## FIRST FLOOR PLAN REVISIONS AT STAIR 1

FIRST FLOOR PLAN REVISIONS AT STAIR 4

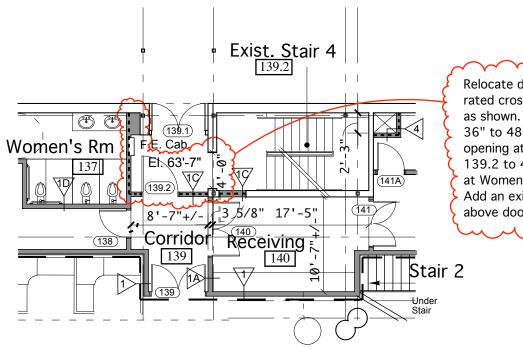
Relocate door 107 as shown.
Relocate door 108.1 into new
1 hour rated cross corridor
partition type1C as shown. Provide
48" wide GWB finished doorway
opng. at former location of door
108.1. Revise partitions enclosing
corridor to be 1 hour rated. At
corridor ceiling provide 1 hr. rated
gwb ceiling assembly at underside
of structure above consisting of
5/8" GWB on metal suspension
system in addition to the suspended
ACT ceiling specified for this area.
